# SITE PLAN WITH ADJUSTMENTS

# 2252 TOWER ROAD

### COVER SHEET

## SITE AND UTILITY PLAN

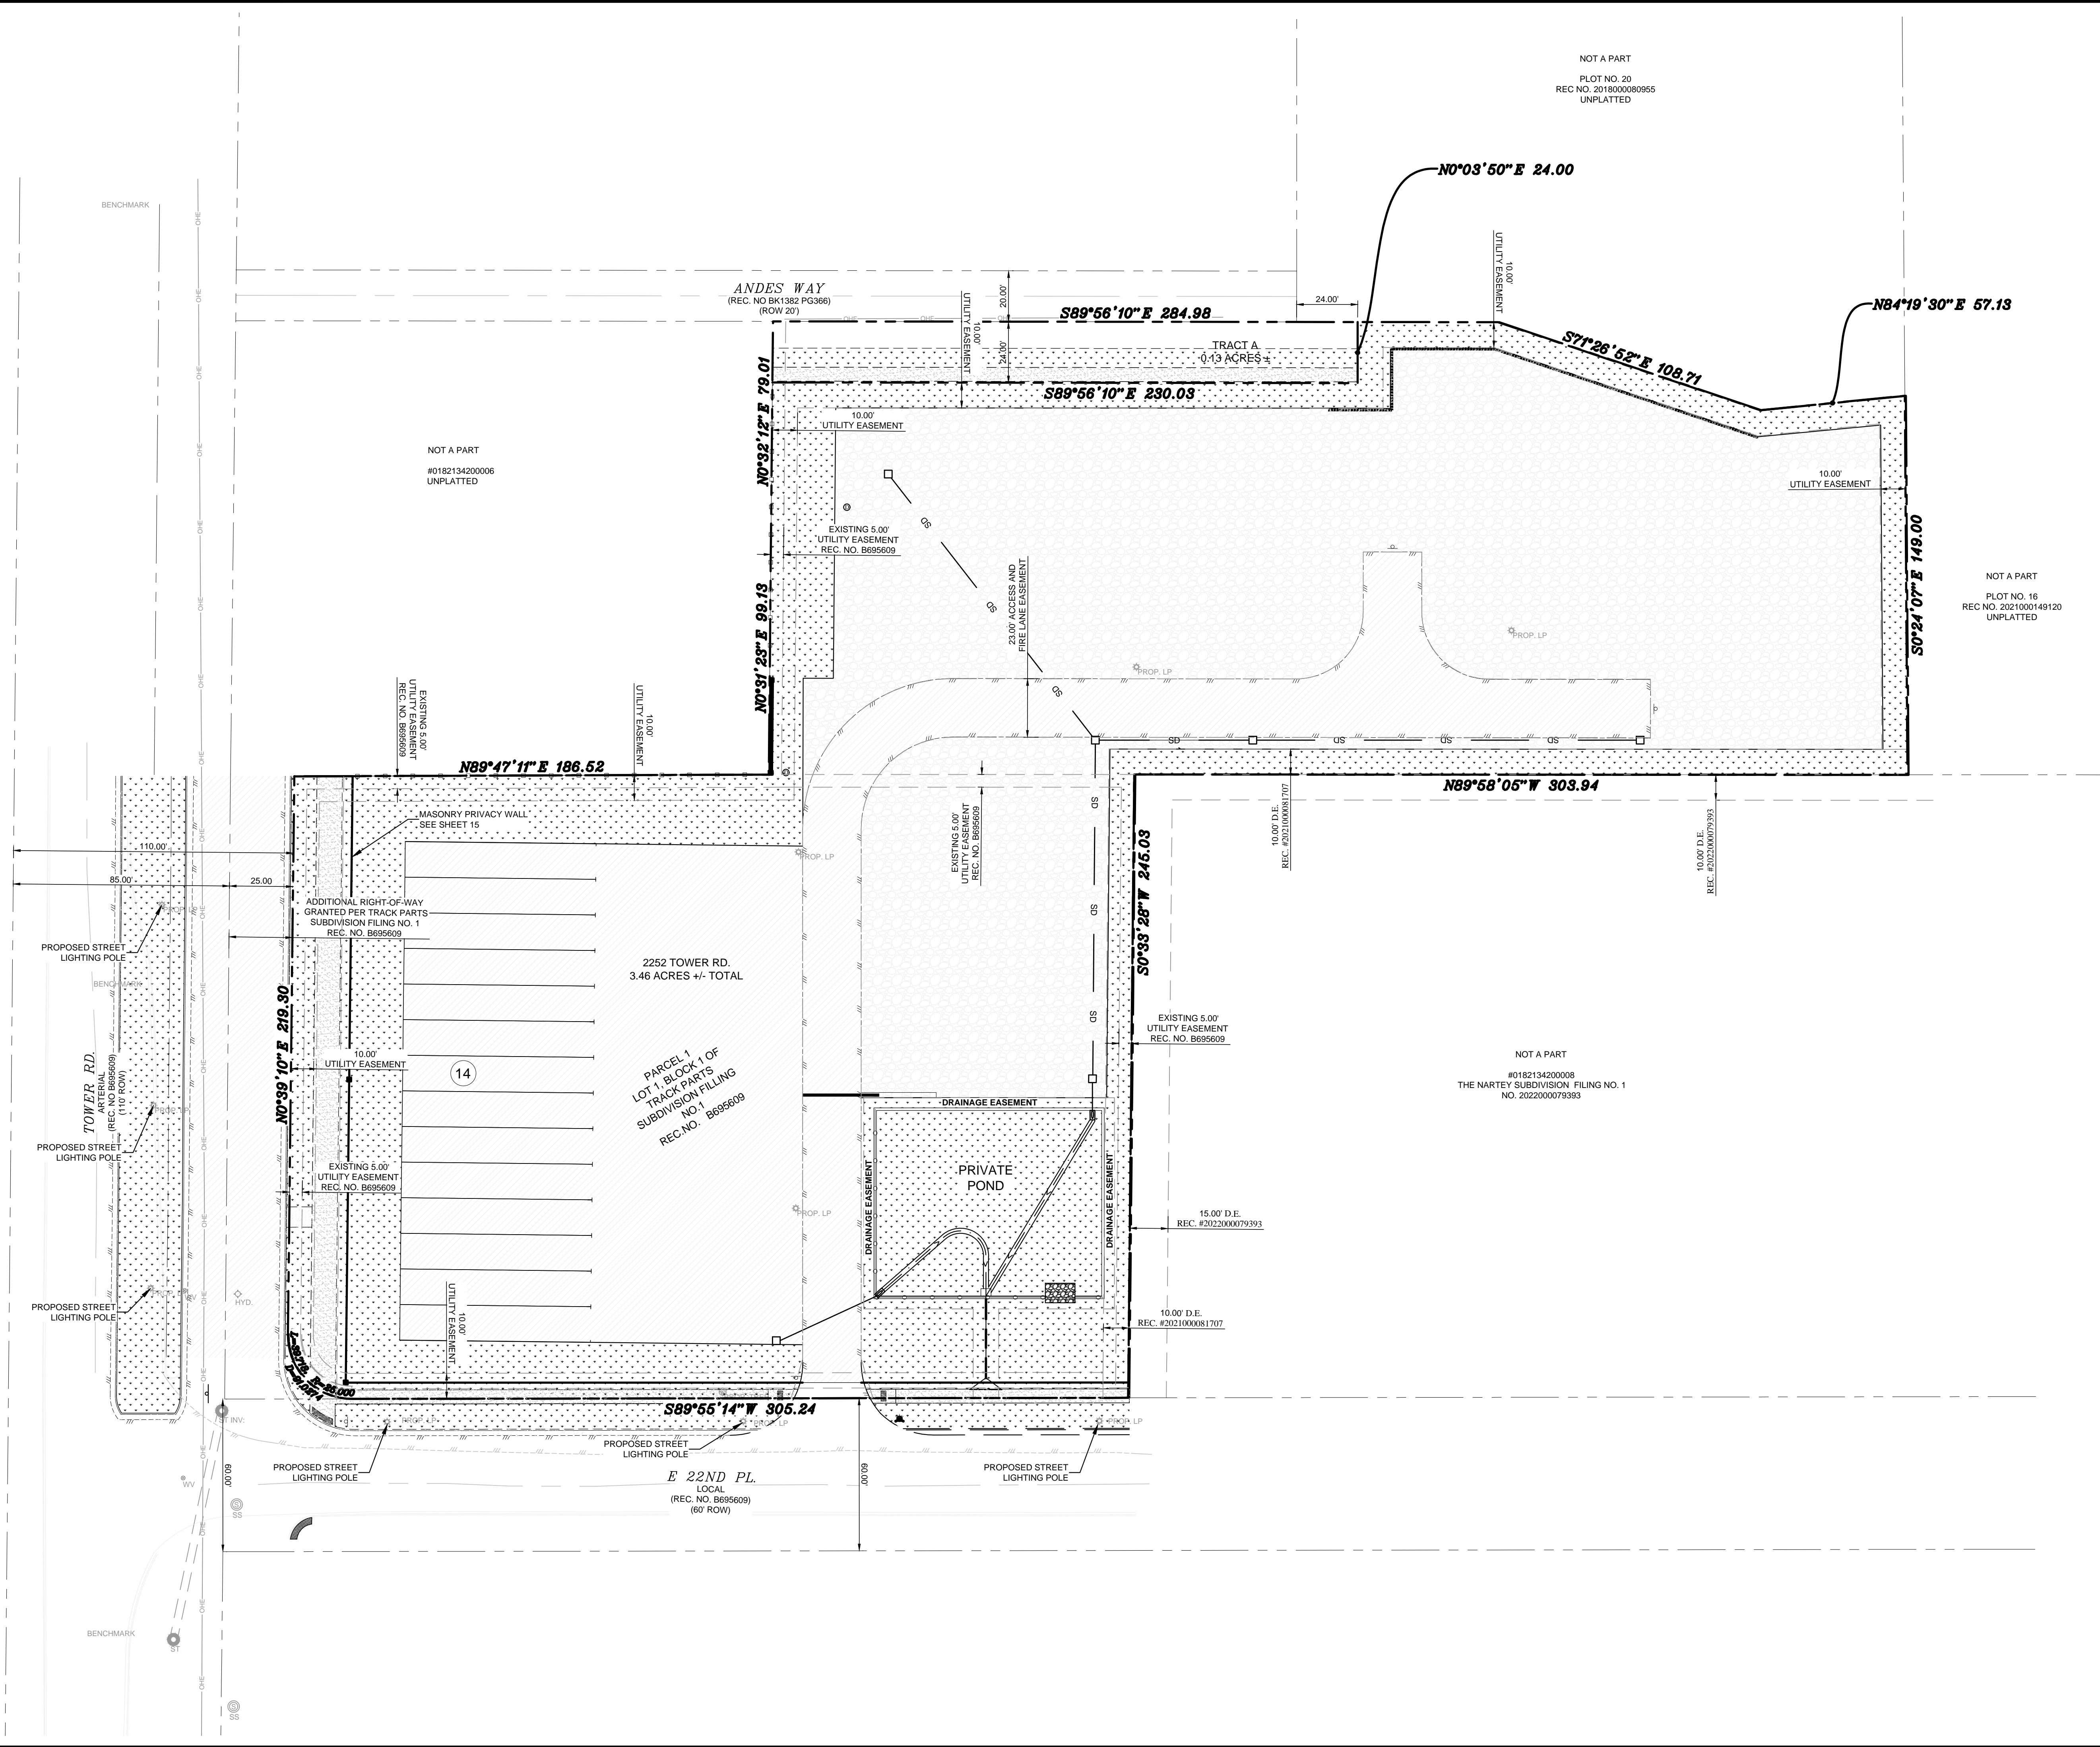
9B. Repeat Comment: The curb ramp on the SE corner of Tower Rd/22nd Place intersection is required to be updated (all sheets). We would need the existing ramp to be redesigned and aligned to accept the receiving ramp to the north.

9G. Please show an asphalt pavement hatch for the width of the roadway that this project is responsible for and to at least cover the area that is currently unpaved, and any pavement reconstruction that is necessary to connect to good pavement, typical all sheets.

DETENTION POND PLAN AND  
SECTION

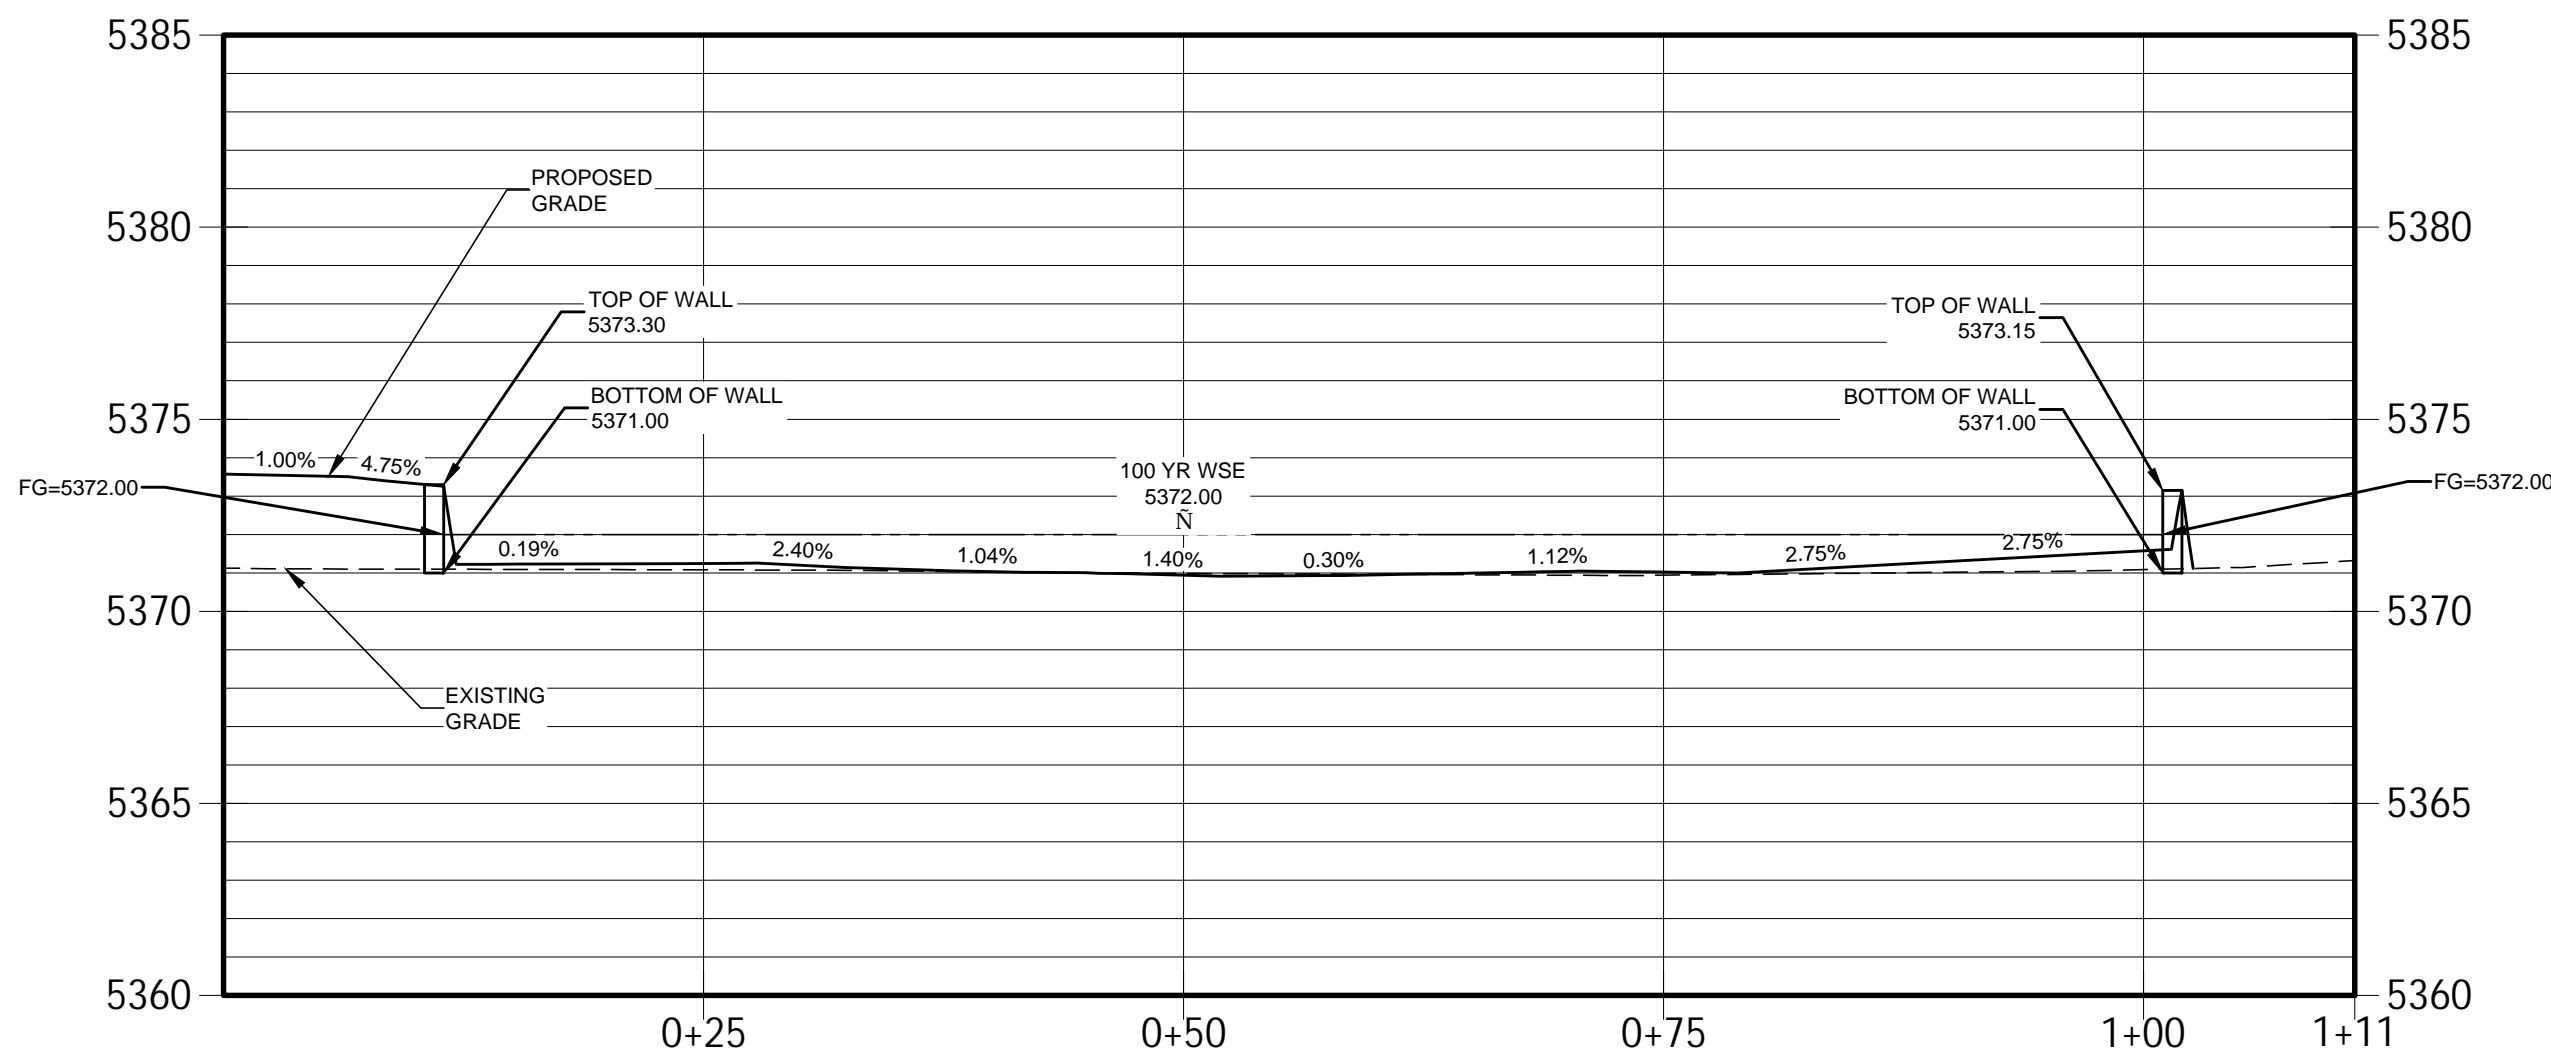
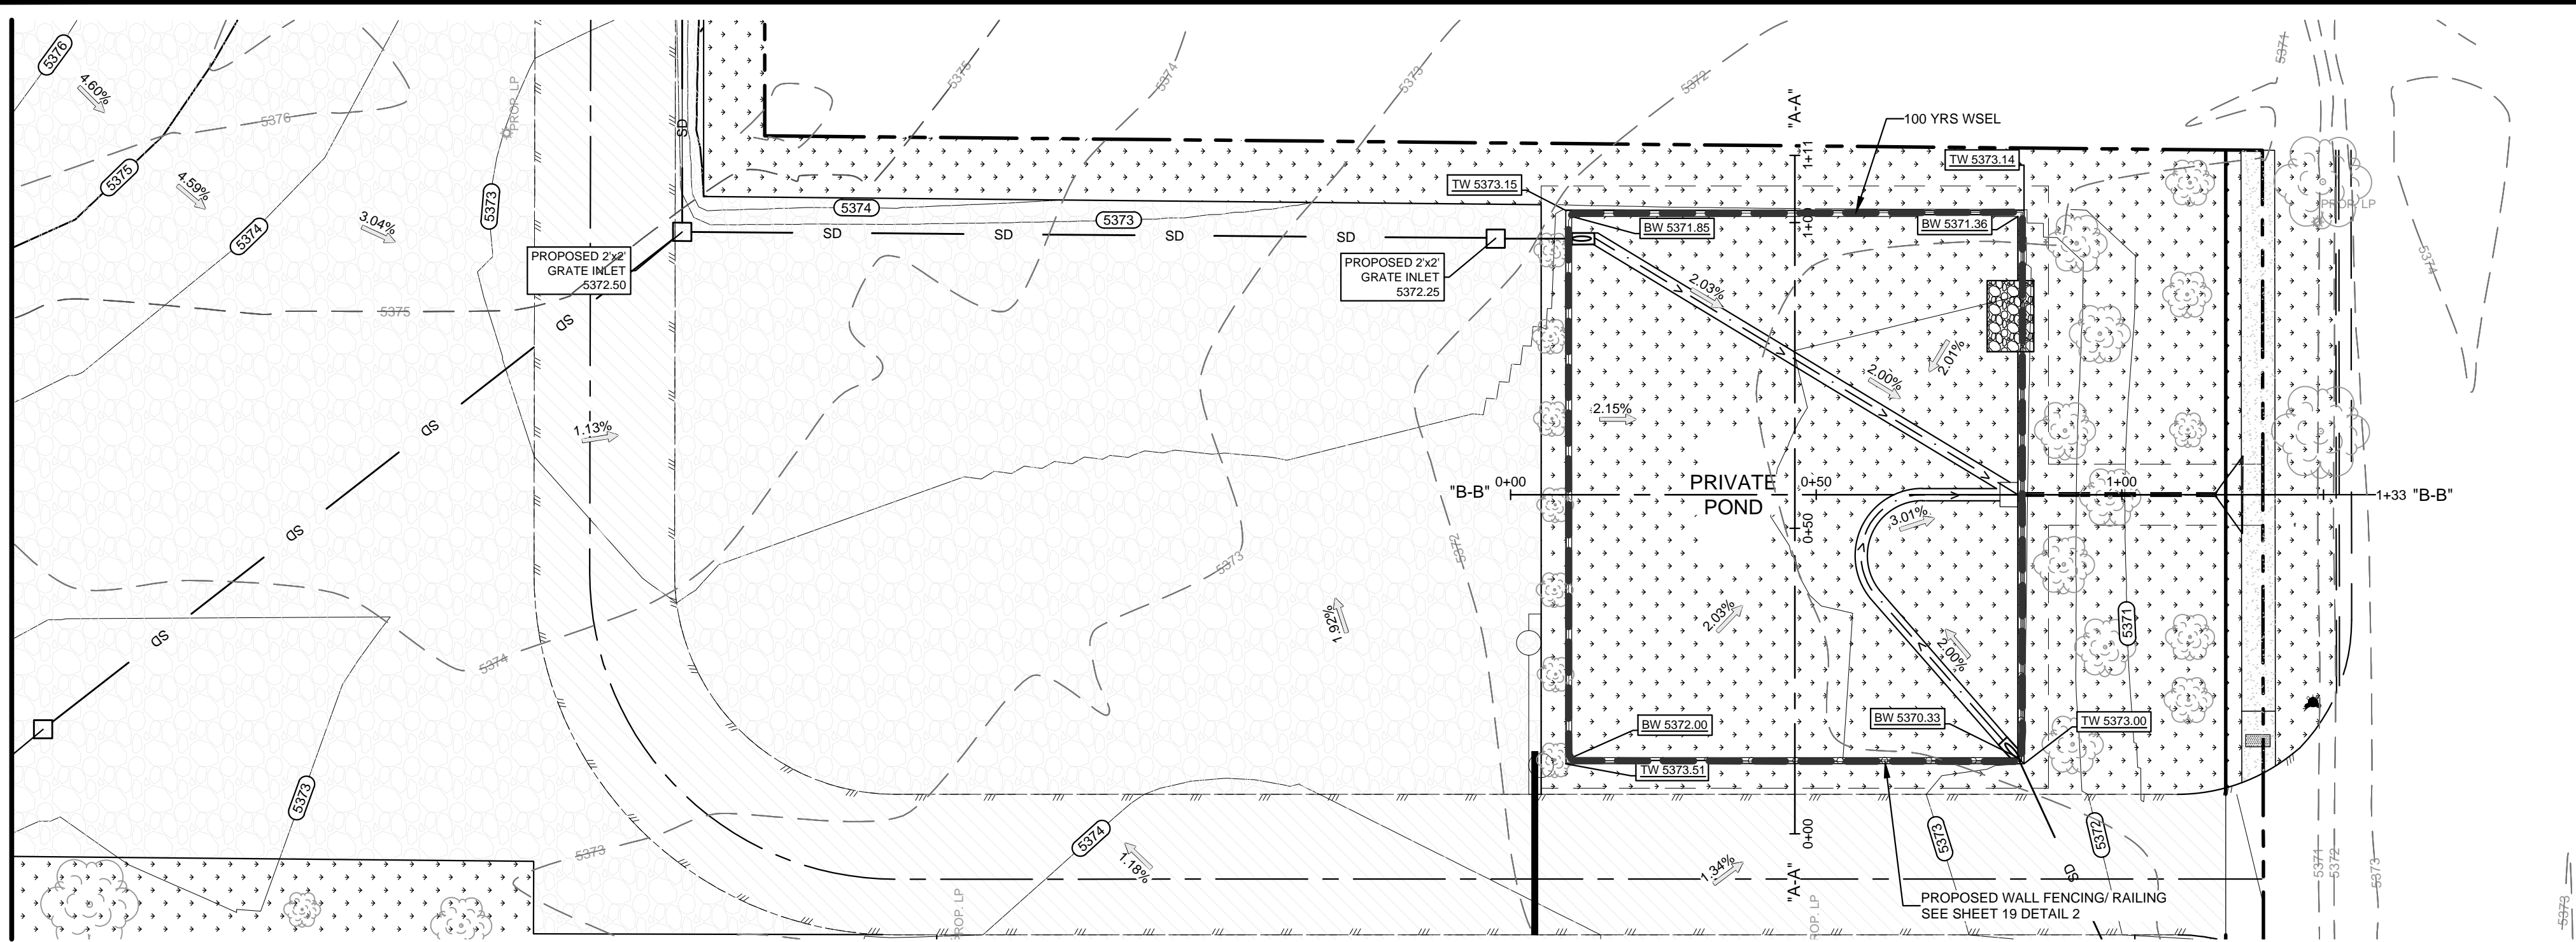
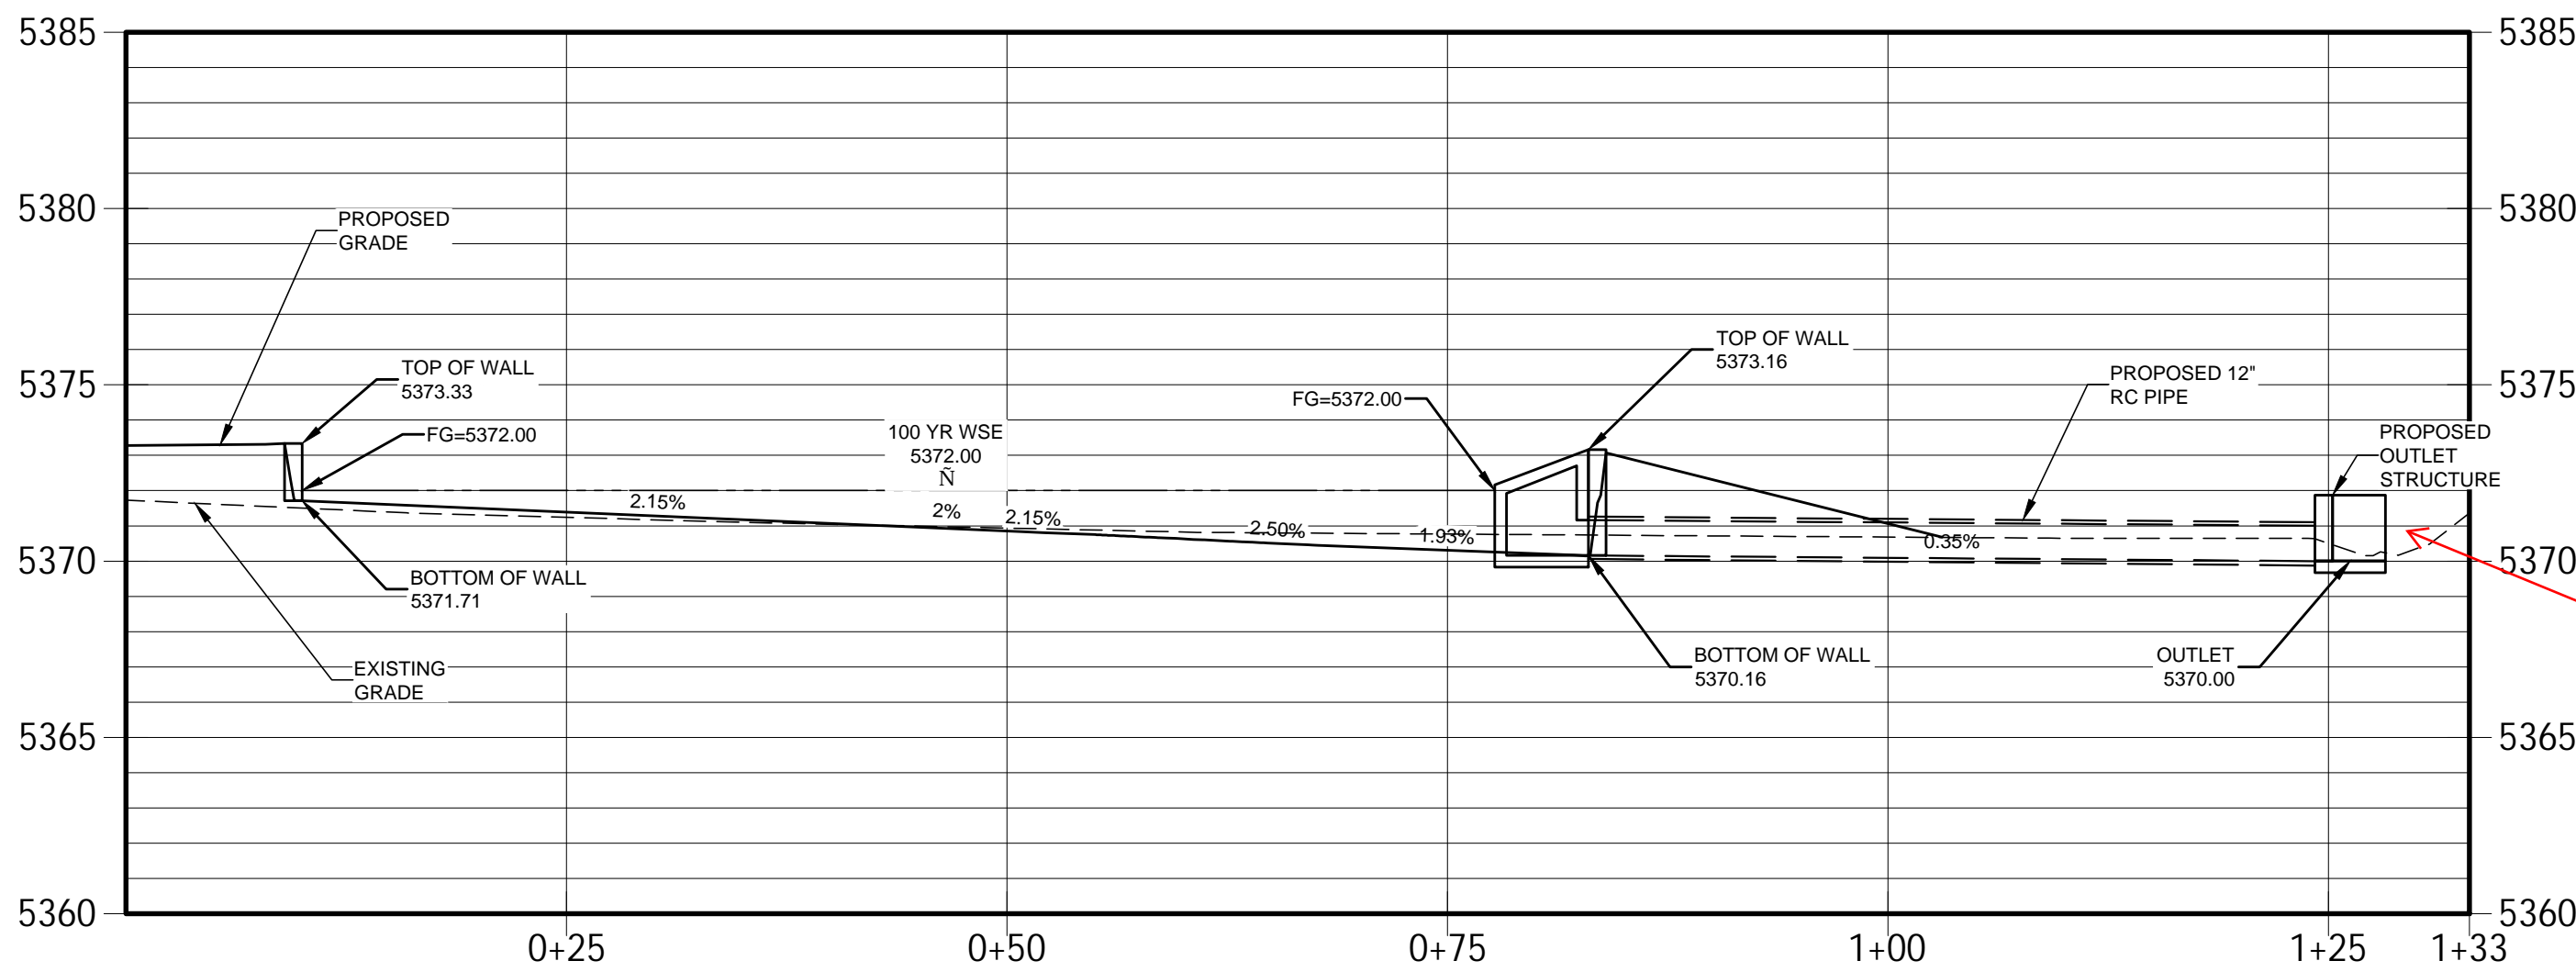
Show outlet  
connection to  
existing storm main;  
see comment on  
Utility Plan

9H. New comment based on new information. Per section 4.02.7.06.1 of the Roadway Manual, railings are required on any walls in excess of 30". This wall is at 32" at this point.
